Nomad

SERVICE BULLETIN

WINGS - DEACTIVATION OF DE-ICE AND OTHER SYSTEMS

NMD-57-20

Figure 2 Fuel Cap Adapter (Sealing Valve)

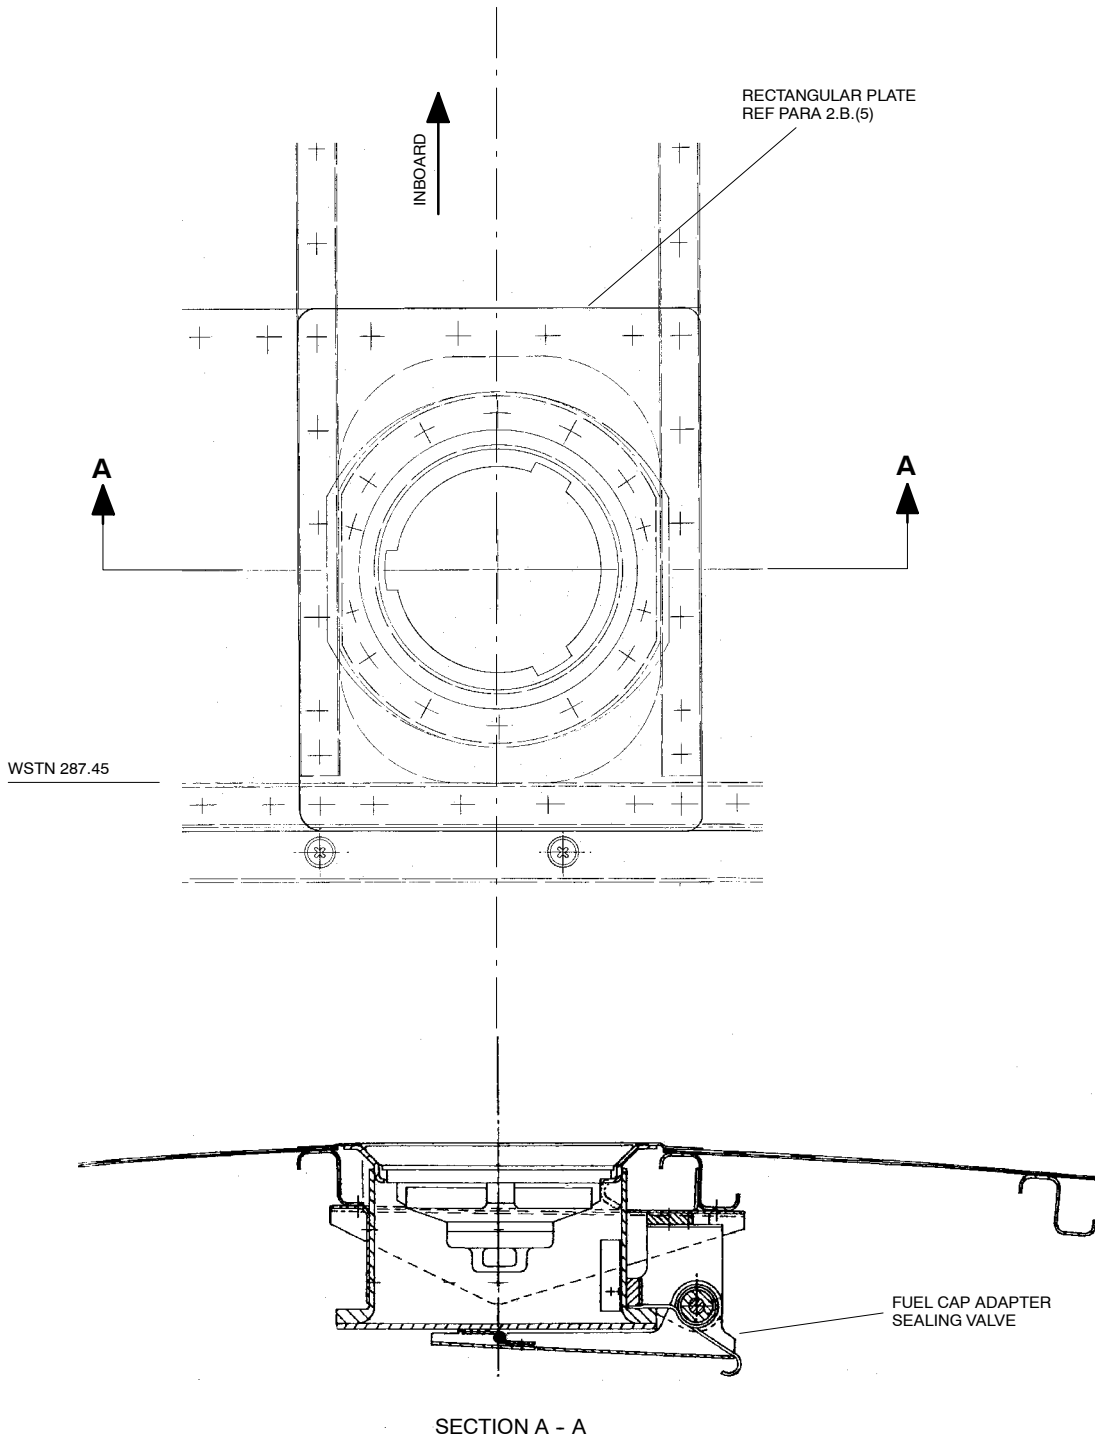
De-rievet the rectangular 0.040 in plate on top of the wing and remove Fuel Cap Adapter Sealing Valve, rivet new rectangular plate 0.040 in 2024-T3 (same size) in its place using Cherrymax CR rivets of appropriate diameter and length, picking up existing hole pattern. Wet Assemble as per Ref. (1) Chapter 20-30-00.

Figure 3 Fuel sump, Fairing and Contents Transmitter details

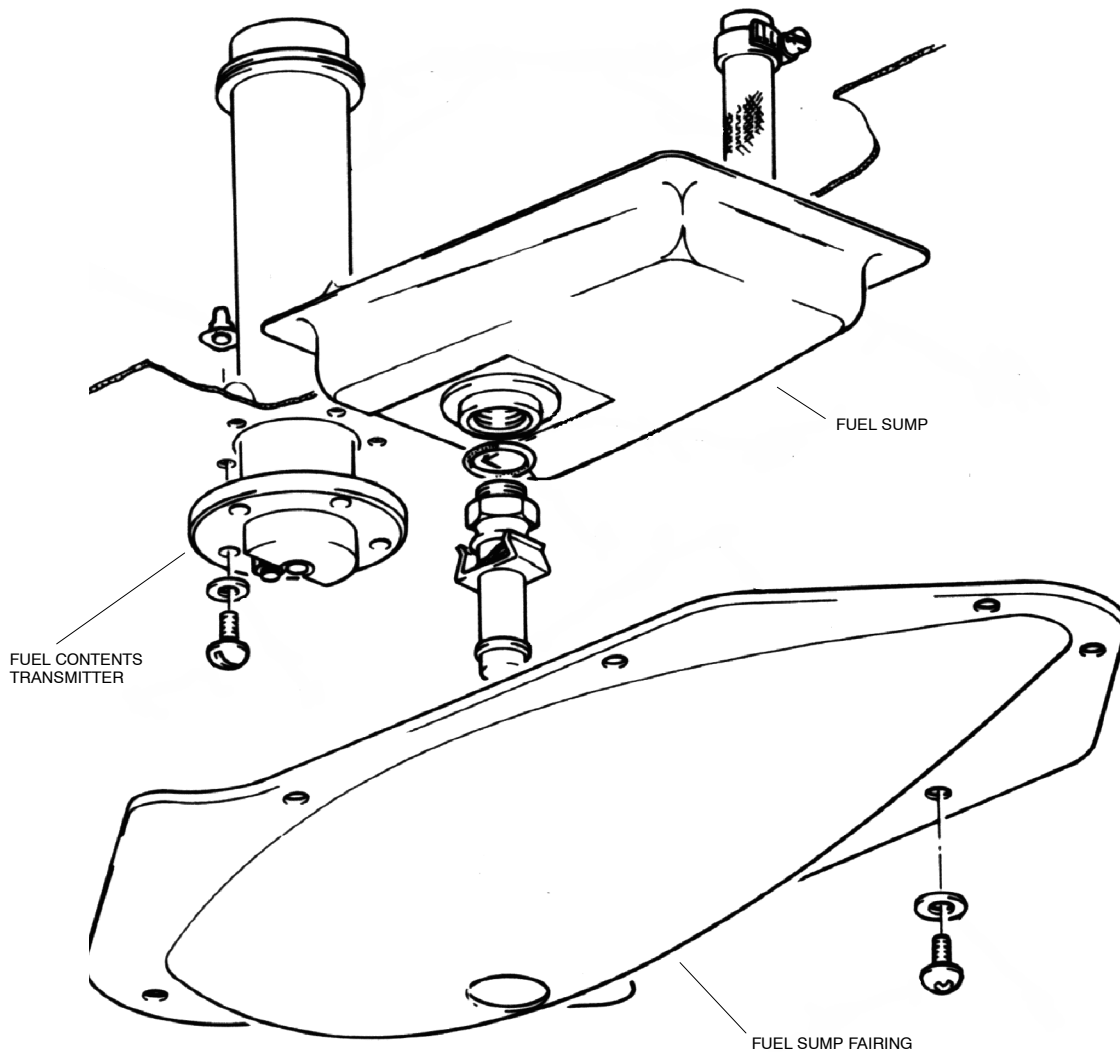
Remove plastic fairing. Then remove metal tray (1/N-20-793) and rivet in place 0.040 in 2024-T3 plate (approx 6.5 in by 9.5 in) using Cherrymax CR rivets of appropriate diameter and length. Wet assemble as per Ref (1) Chapter 20-30-00. Replace original fairing screws to plug anchor nuts.

Remove, and bolt on blanking plate, approx 3.0 in diameter 0.040 in 2024-T3, with original screws.

Figure 4 Tank Structure (viewed from above)

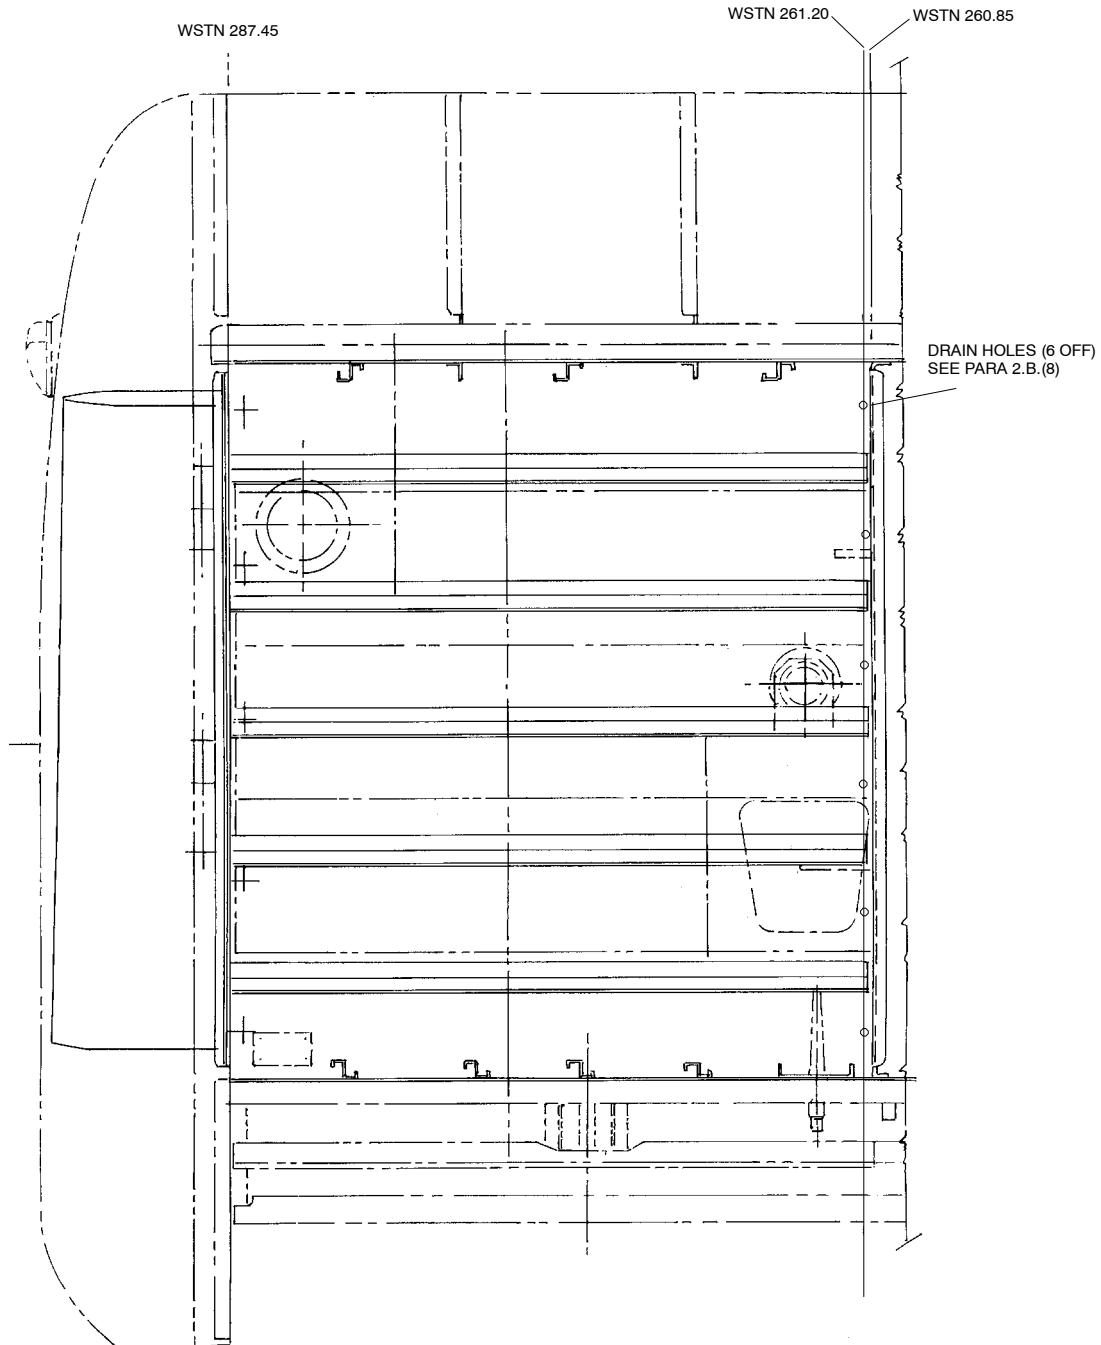
As tank bay was sealed, new drain holes must be drilled. Drill 6 off 3/16 in holes in bottom skin at WSTN 261.2, midway between each pair of stringers, and between spar caps and adjacent stringer. Brush alodine exposed metal and touch up with epoxy primer per Ref. (5). Chapter 51-30-00.

Figure 5 View Showing Stall Breaker Strip Location

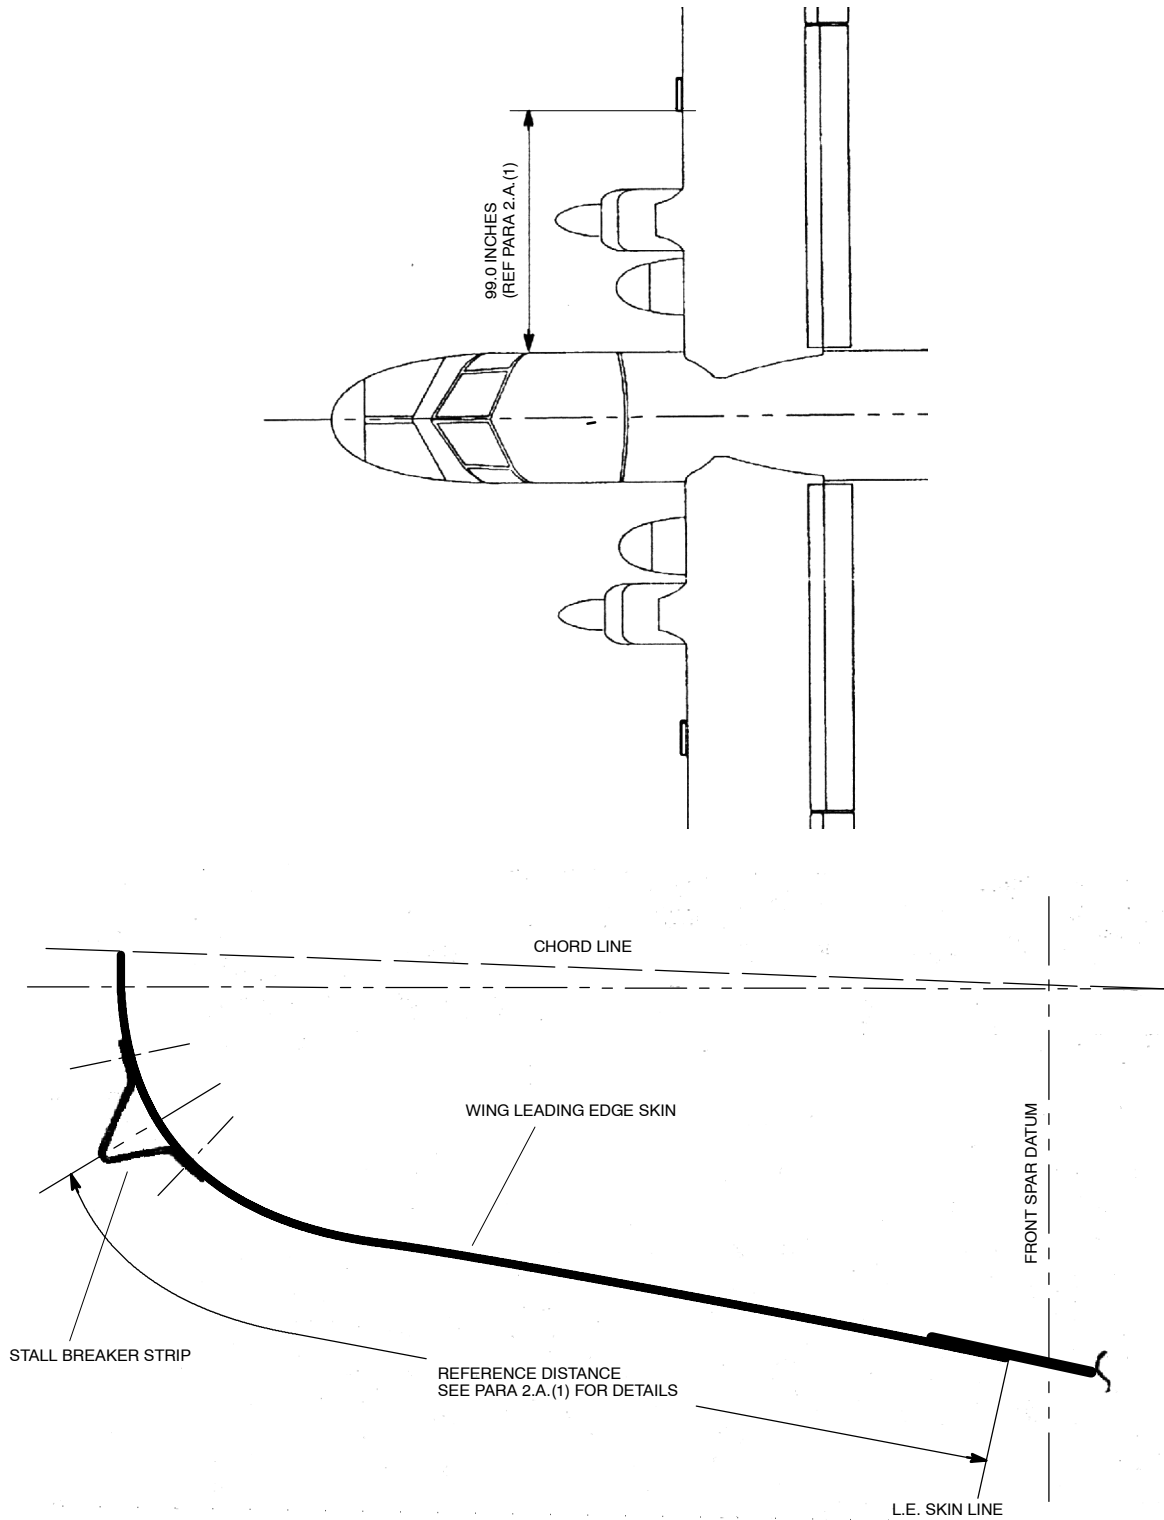
Figures 5 and 6 are provided for reference. It is suggested that prior to the removal of the De-Icing boots from the right wing leading edge, measurements are taken of the position of the existing rubber Stall Breaker Strip. These measurements may be compared with similar measurements from the LH wing.

- (1) For reference the inboard edge of the Stall Breaker Strip is at wsta 99.0 in (Ref Fig 5 and the position of the apex of the Strip on the leading edge of the wing is 10.4 in forward of the leading edge skin line (Ref Fig 5).

- (2) A new Stall Breaker Strip (Part Number 1M/N-20-610) should be offered up to the RH wing leading edge in as near as possible to the measurements taken above, and attached with double-sided adhesive tape. The object being to position the apex of the new metal Stall Breaker Strip as near to the position of the rubber Stall Breaker Strip.

Figure 6 Detail of Stall Breaker Strip Attachment (RH Wing)

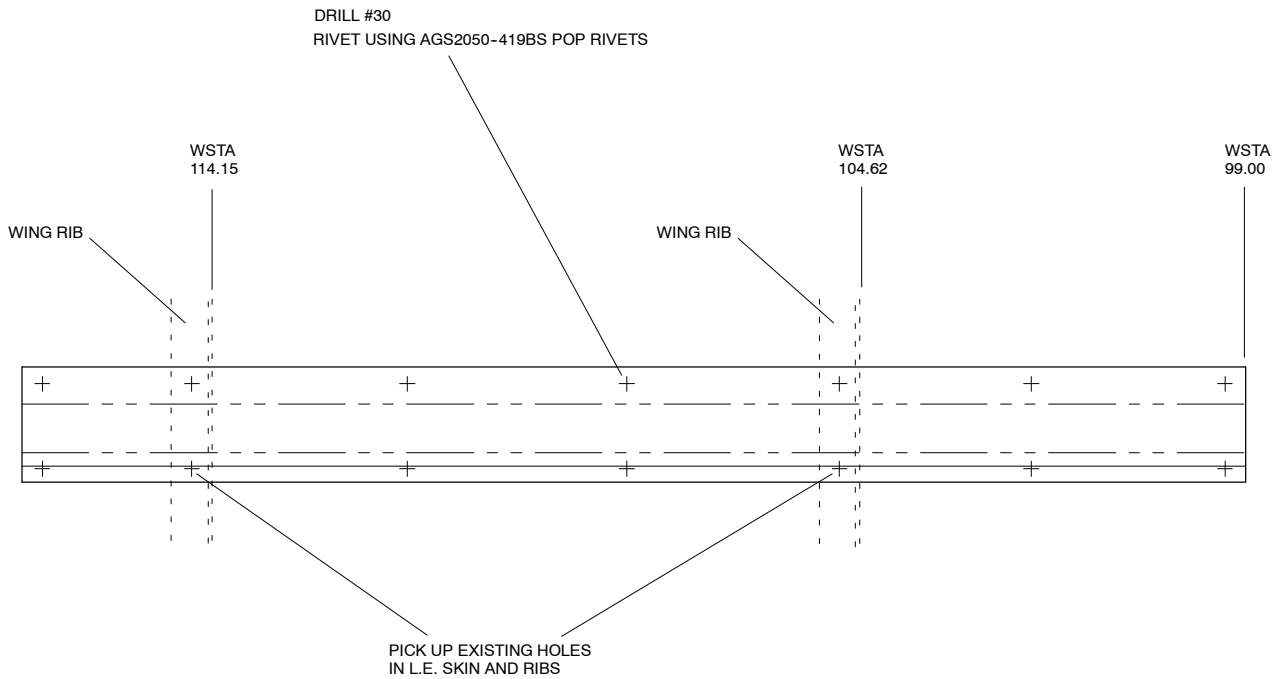
- (3) The procedure for conducting flight tests to determine the correct final position of the Stall Breaker Strip is detailed in Para 3.A.(2).
- (4) On satisfactory completion of the above tests the Stall Breaker Strip should be finally fastened to the wing leading edge skin as follows (Ref Fig 6):

- (a) Locate Stall Breaker Strip in final position.
 - (b) At wing rib positions (wstas 104.62 and 114.15) drill out existing rivets and back-drill (#30) into Stall Breaker Strip.

- (c) Drill (#30) wing leading edge skin from rest of holes in Stall Breaker strip.
 - (d) Deburr all holes. Wet assemble and rivet in position.
 - (e) Touch-up prime and paint as required.
